## ARLINGTON AVENUE BRIDGES REPLACEMENT

Design Review Committee Meeting #13 | May 12, 2023

# Purpose of Today's DRC Meeting:

# Pipe Outlets Through South Floodwall

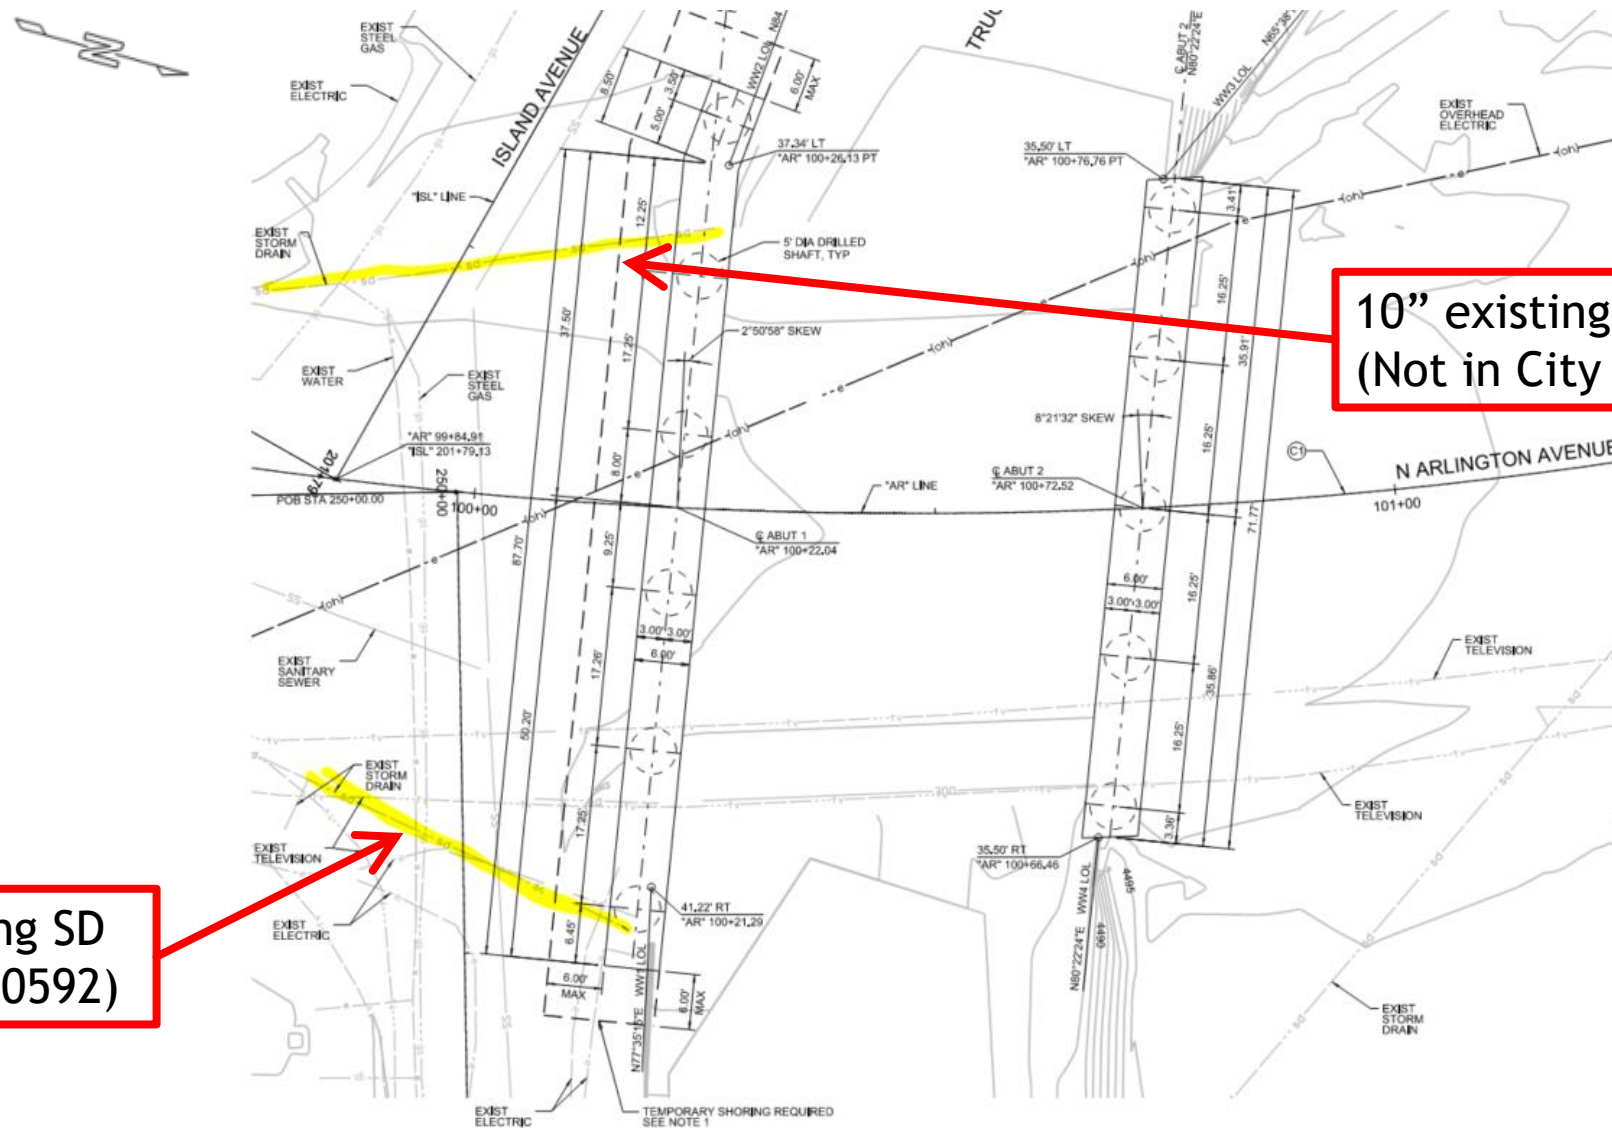
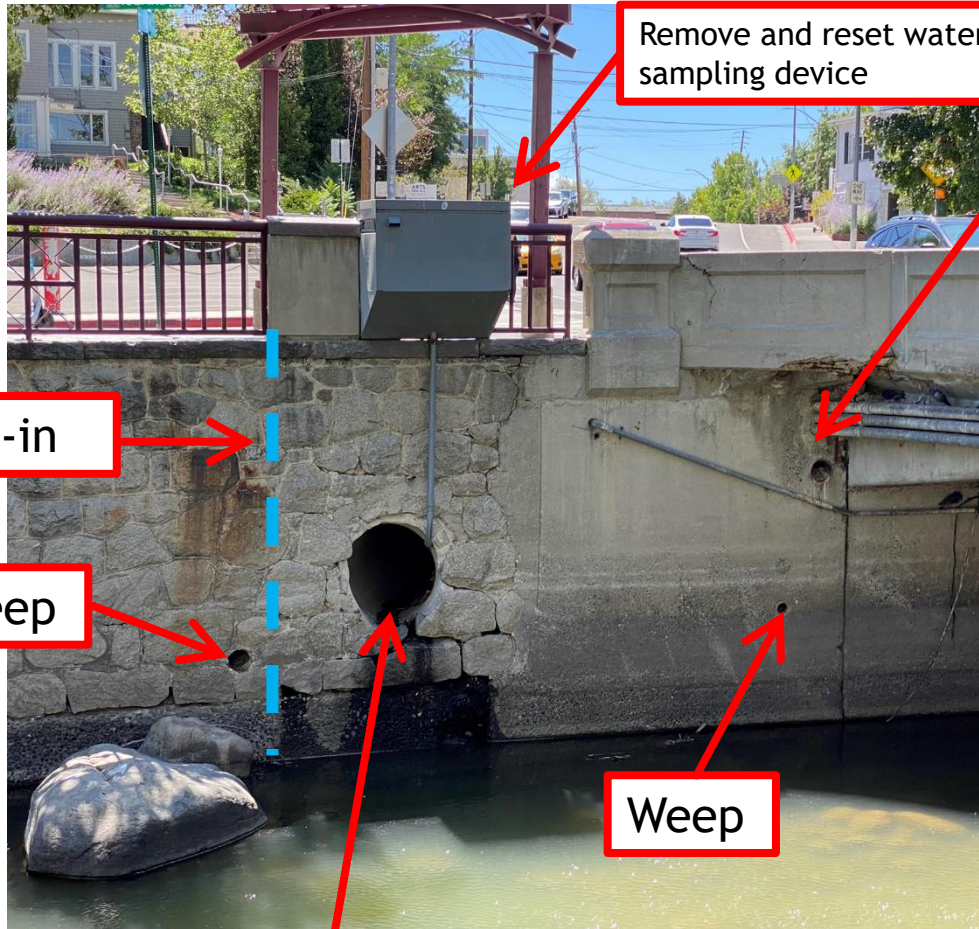
No Flapper -  
Water  
Sampling  
Device

# Pedestrian Path Under North Bridge Drainage

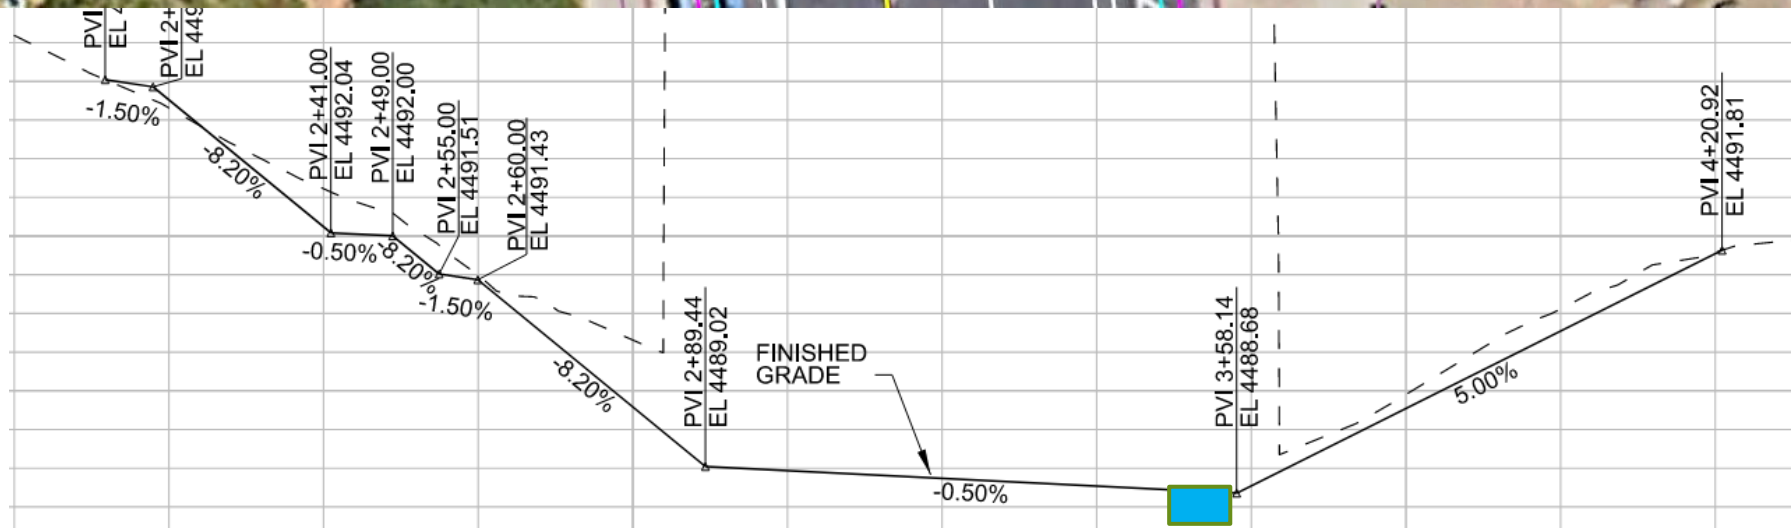
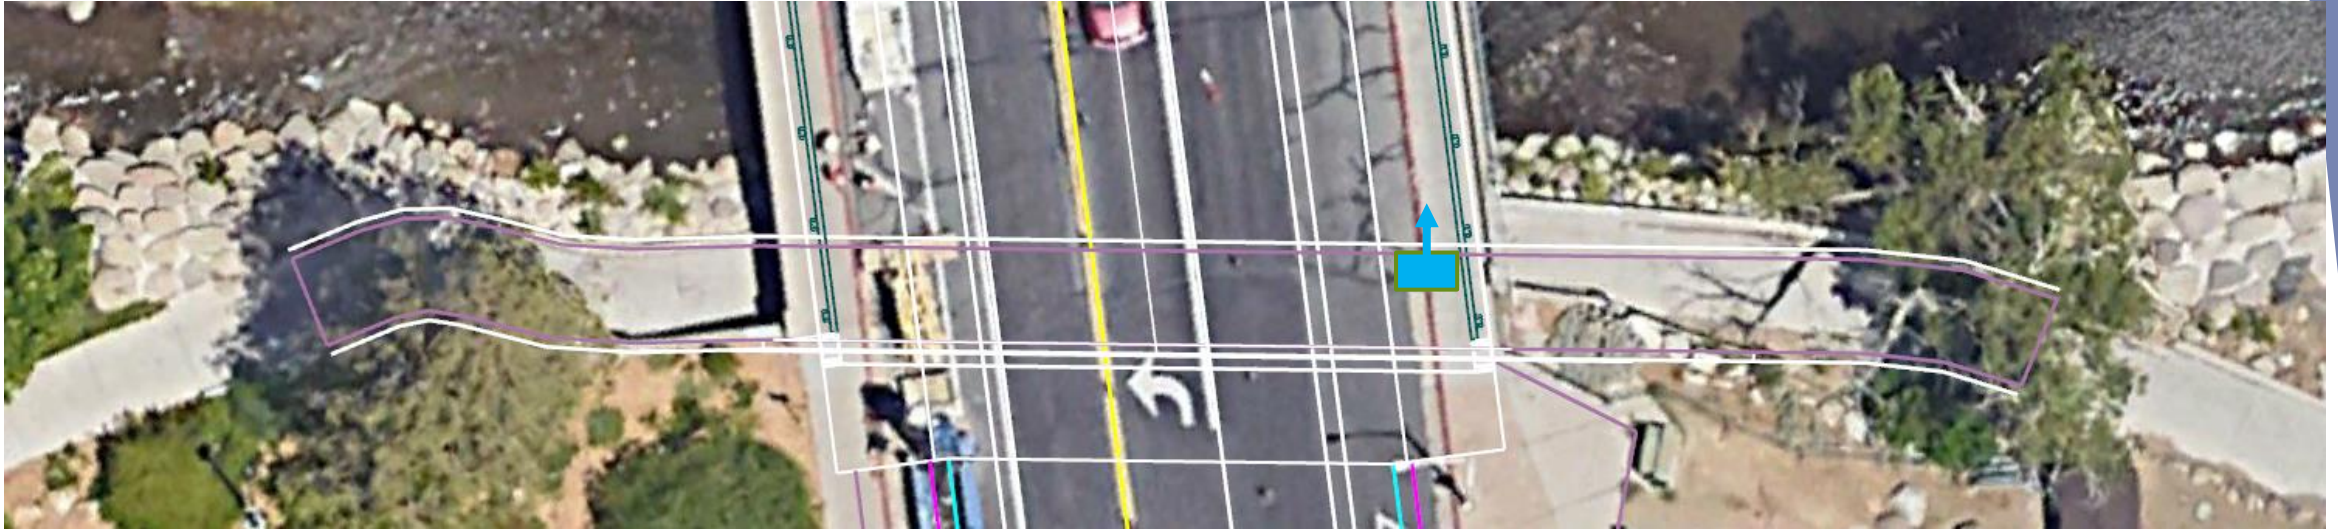
- ▶ Photo: May 2, 2023
- ▶ Approx. 1' Standing Water
- ▶ No Signage that Path Access was Closed

- Ped/Bike friendly inlet at low spot
- Simple outlet pipe with duck bill or flapper - design pipe & inlet so easy maintenance of debris

## j) Curb Returns

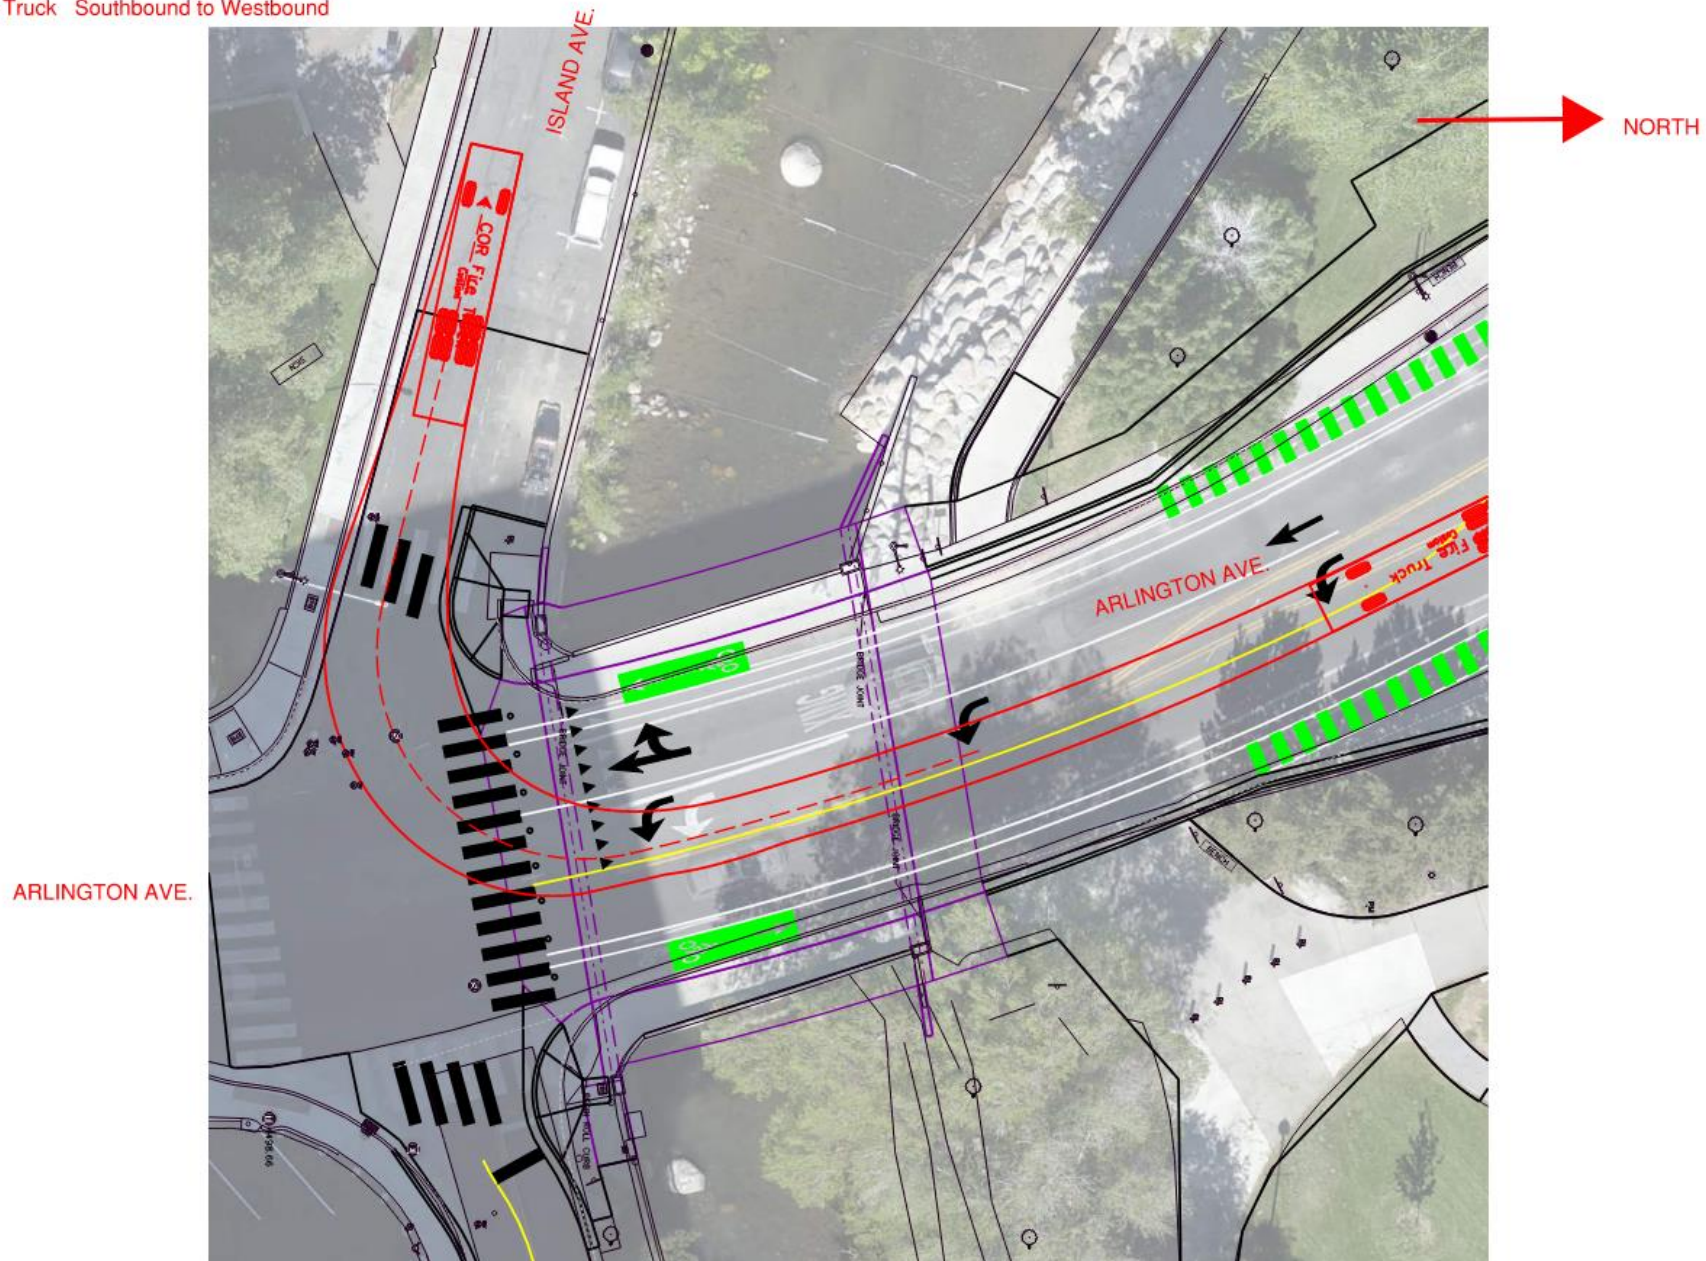
Northwest corner: Existing (to remain) is:	5'	
Northeast corner: Existing (to remain) is:	15'	
Southeast corner: Design is:	23.5'	(Existing is 22')
Southwest corner: Design is:	35'	(Existing is 40')

An exception is requested for all curb returns with radii less than 30 feet as existing curb return radii are being perpetuated. The existing curb returns are constrained by existing buildings, right of way, and bridge structures.

City of Reno Fire Truck Southbound to Westbound with Optional Mid-Block Crossing

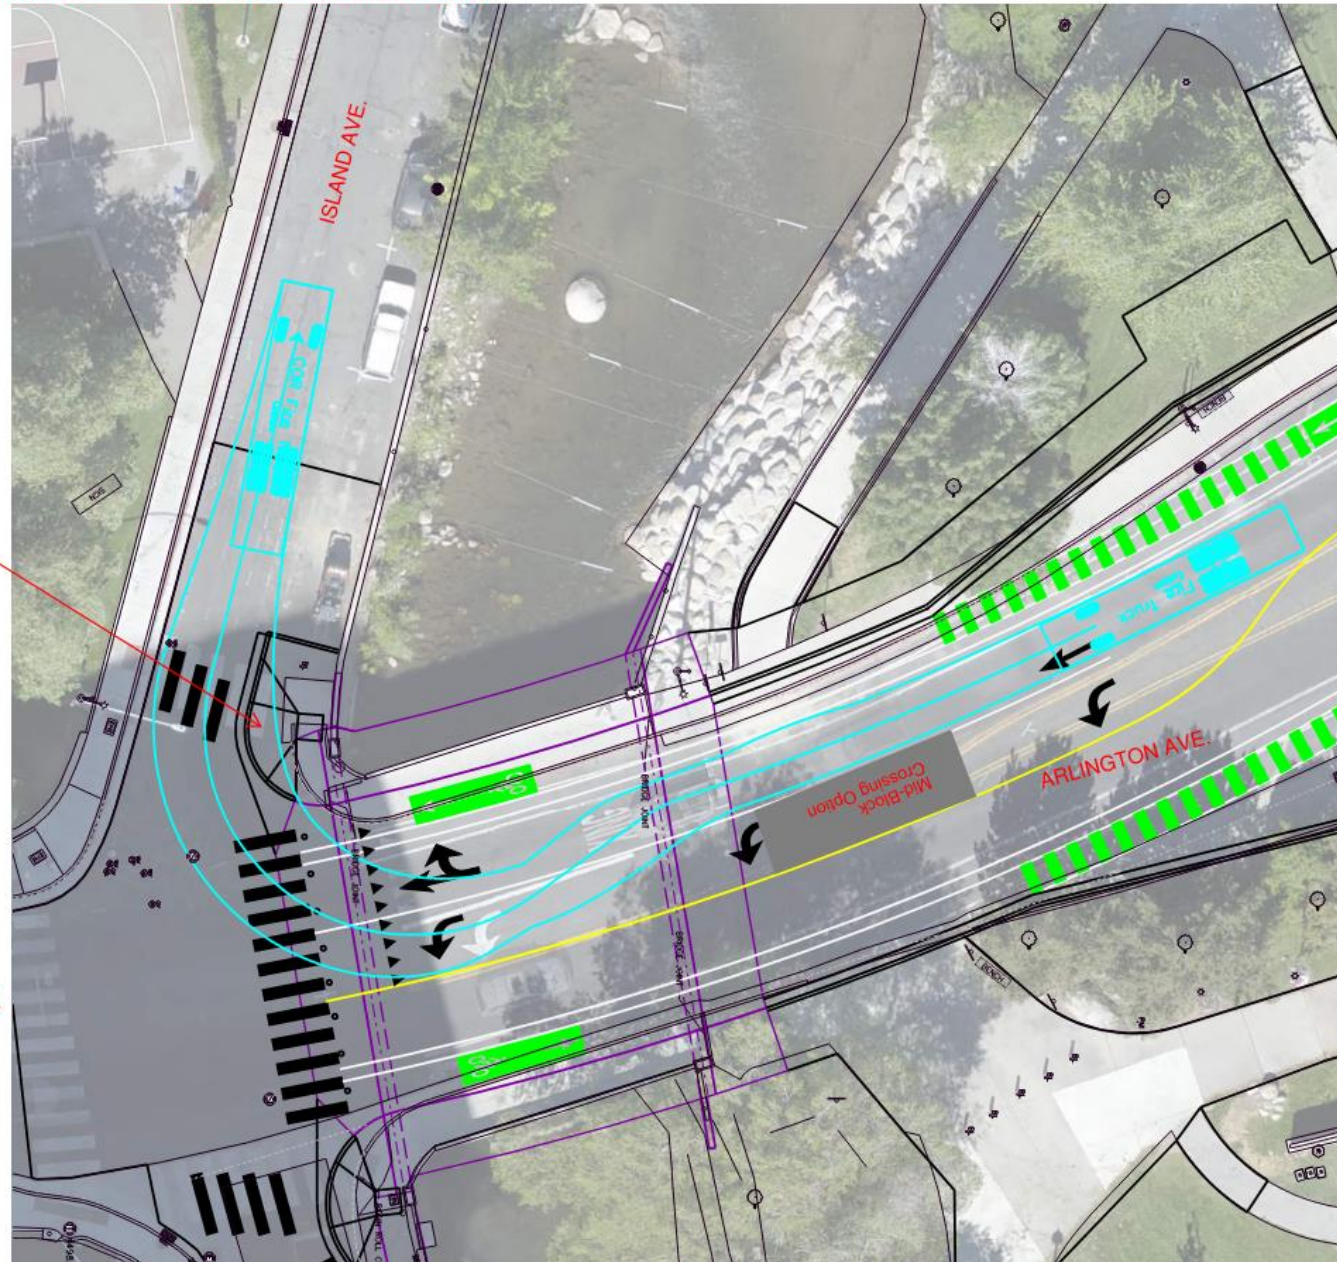
If Mid-Block Crossing Allowed, No Bulb-Outs

## k) Obstructions w/in Sidewalk

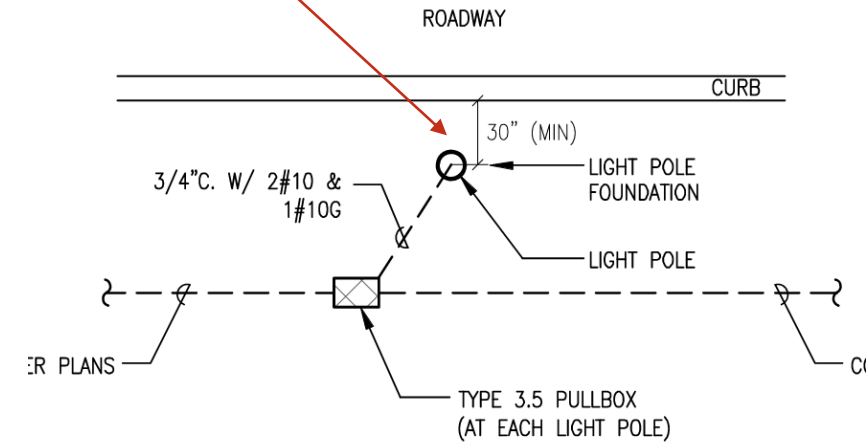
An exception is requested for the Pedestrian Scale lights, transit route signs, and pedestrian push button signal poles required to be placed within the 8' sidewalks, along the back of sidewalk, along Arlington Avenue. Ensuring uniform lighting distribution across the roadway require the placement of pedestrian scale lights along the back of the sidewalk. ADA requirements limit the ability to place pedestrian push button poles outside of the sidewalk. The extra width provided by the 8' sidewalk versus a standard 5'-6' sidewalk provide adequate mobility around these required obstacles.

Discussions with CoR on 5/5 and agreed by RTC:  
Place as far back on sidewalk as possible -  
Don't want poles 2.5' from back of curb in middle of our wide 'pedestrian friendly' sidewalk;  
Redo light analysis and Adjust light spacing as necessary
